0 001 510 .. - QB,24V 9PS Alteration to drive spindle VDT-I-001/107 B Ed. 1 7.1975 Translation of German edition of 19.5.1975

0 001 510 ... - QB 24 V 9 kW (9 HP)

Modification to multiplate clutch and pole-shoe mounting.

<VDT-I-001/105 B > Edition 1.1975 Translation of German edition of 3.12,1974

Fig. 1 old type

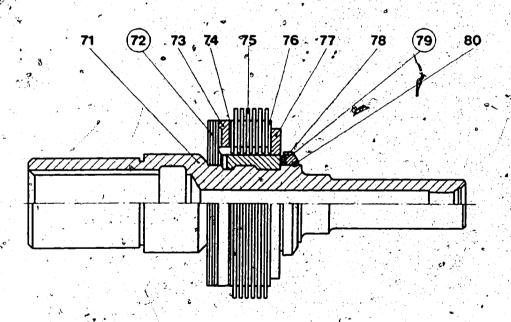
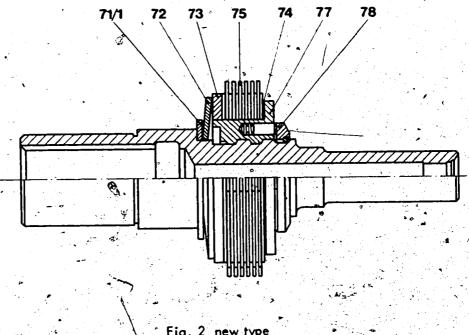
The new drive spindles are interchangeable with the old. The 4 spring washers (pos. 72) have been replaced by a conical spring washer. The spring washer (pos. 79) between the coupling nut and the stop ring has been replaced by 4 helical compression springs and 4 straight pins in the pressure sleeve. Apart from this, the shims (pos. 74) are no longer mounted between the last steel clutch disc and the thrust ring, but rather between the clutch collar and the first steel clutch disc.

The installation positions of the conical spring washer (pos. 72); the helical compression springs with the straight pins, the shim (pos. 71/1) and the shims (pos. 74) can be seen from the section drawing (fig. 2).

Parts set 2 007 010 044, with the pos. 71/1 - 80, is intended for the repair of old drive spindles, and for converting them to the latest design. It is obtainable through the usual channels.

Fig. 1 Multiplate clutch

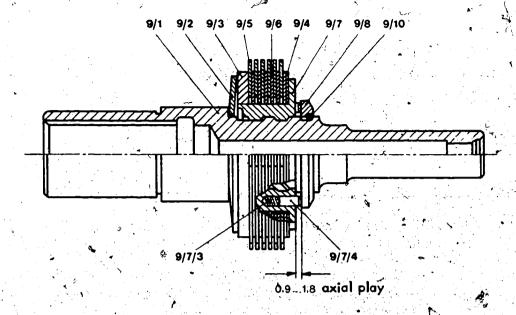
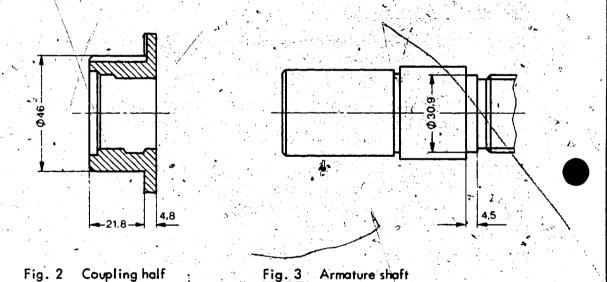
The following components are modified (see Figs. 1 ... 3 and the specified item:numbers on the service-parts microfiche):
- Armature shaft (frem 9/1): The length of the disc spring seat changes from 5.5 to 4.5 mm, the seat diameter being 30.9 instead of 30.2 mm (Fig. 3).

There is no change in the disc spring (Item 9/2).
- Coupling plate (Item 9/3): The thickness of the coupling plate is increased from 3,4 to 3,6 mm, the plate being designed as a friction plate. Consequently, one steel plate is no longer required, so only 6 steel plates must be used with the new drive spindle.
- 1.4 Shims (Item 9/4a...g): The inside diameter of the shims is increased from 45.5 to 46 mm.
- Coupling plates (Items 9/5 and 9/6): The thickness of coupling plates Items 9/5 and 9/6 is increased from 1.2 to 1.45 and 1.4 mm respectively.
- Coupling half (Item 9/7): The coupling half is now extruded, its diameter, being 46 mm (Fig. 2).

There is no change in the helical compression springs (Item 9/7/3) and straight pins (Item 9/7/4).
- 1.7 Stop ring (Item 9/8): The width of the stop ring is reduced from 4.8 to 3.8 mm.

Fig: 5 Old type before FD 821

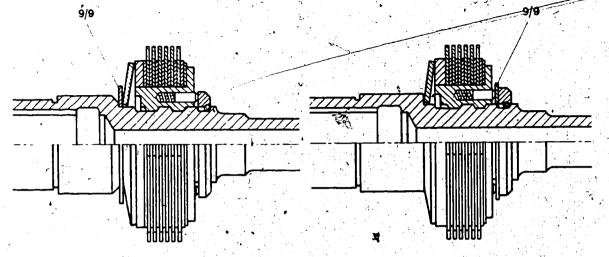
The shim (Item 9/9) must be fitted in accordance with Fig. 6 when carrying out repair work on the new multiplate clutches, and according to Fig. 5 (clutch chamfered) in the case of old-type clutches.

Overload protection 200 ... 240 Nm (20 ... 24 kgfm) Axial play of coupling element 0.9 ... 1.8 mm

Needle roller bearing

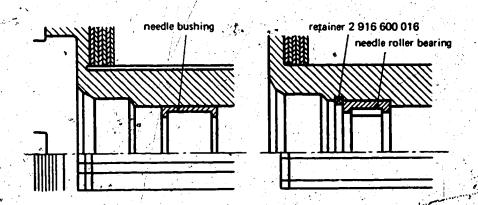
As from FD 521 (date of manufacture January 1975), only armature types with needle roller bearing and retainer will be manufactured for "T" starting motors, the part number remaining unchanged.

The part number of the needle roller bearing is changed from 1 900 910 109 into 1 000 910 002. The needle bushing 2 000 910 003 can still be obtained through your authorized representative.

Needle roller bearing and sleeve are not interchangeable.

Engagement rod (Fig. 1)

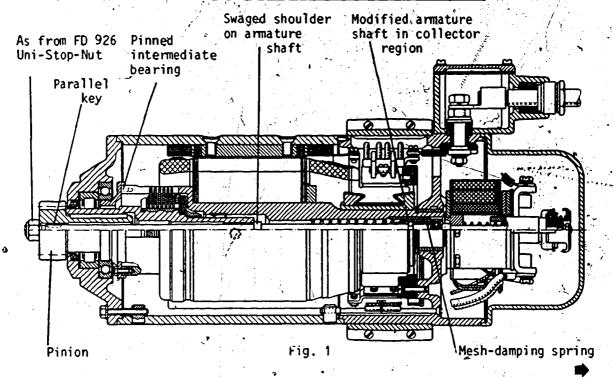
Up to date of manufacture FD 821 (Jan. 78) the engagement rods were delivered with a locking washer, a slot in the threaded section and a pinion-securing nut (Uni-Stop-Nut). When repairing engagement rods of this type, a new locking washer (1 000 146 001) and a Uni-Stop-Nut 2 003 315 002 (M 10x1.5) or 2 003 315 000 (M 10x1) depending upon the thread in question, are to be fitted.

As from FD 822 (Feb. 78) the following modification has been carried out: The slot in the threaded portion is omitted. In its place a 3 mm wide slot was introduced for a parallel key behind the threaded section. This serves as protection against the rod turning relative to the pinion. For this purpose, the pinion was provided with a corresponding slot in its bore.

The engagement rod is now always provided with an M 10x1.5 thread.

The mesh-damping spring has been moved from outside the guide sleeve to inside it.

In replacement cases, only the new-type engagement rod complete as a parts set with Uni-Stop-Nut 2 003 315 002 and parallel key 1 902 300 021 is delivered.

IMPORTANT: When repairing an old starting motor using a new engagement rod (modification as from FD 822) it is necessary to fit a new pinion. On the other hand new pinions (with a slot in the bore) can be used as well for the old-type engagement rods (with locking washer).

A new Uni-Stop-Nut is always to be used when carrying out repairs and tightened with a torque of 35 ... 45 N·m (3.5 ... 4.5 kgf·m).
